HORSHAM DISTRICT COUNCIL CONSULTATION

TO:	Horsham District Council – Planning Dept
LOCATION:	Devine Homes Development Site The Gallops Lower Beeding West Sussex
DESCRIPTION:	Approval of details reserved by conditions 17,20 and 24 to approved application DC/22/0708
REFERENCE:	DISC/25/0191
RE-CONSULT:	1st set of comments in black 2nd set of comments in blue
RECOMMENDATION:	More Information / Modification No objection

Top left: DISC/25/0191
Top right: DISC/24/0162
Bottom: DISC/24/0162

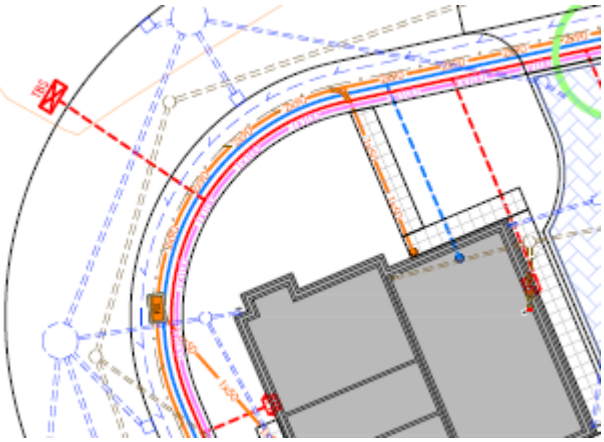
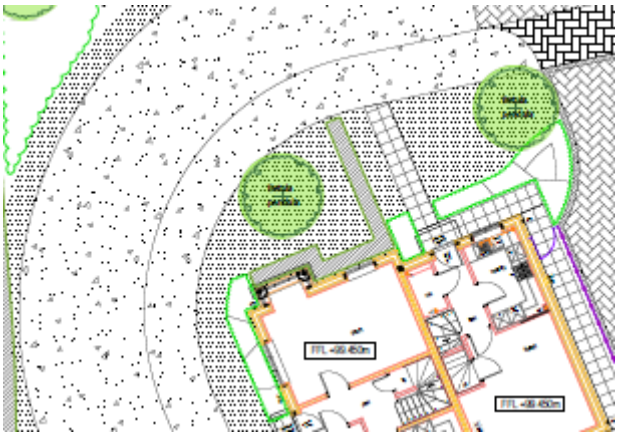
4. While there are no concerns with the proposed EV layout, we note that as a result, the services layout has been altered since that approved under DISC/24/0162 and now has potential to conflict with landscape proposals. In order to ensure the tree can be delivered without being planted too close to the dwelling, we request that the previously approved layout is followed, or confirmation provided that a tree root barrier will be installed upon planting.
   Closed, with thanks.
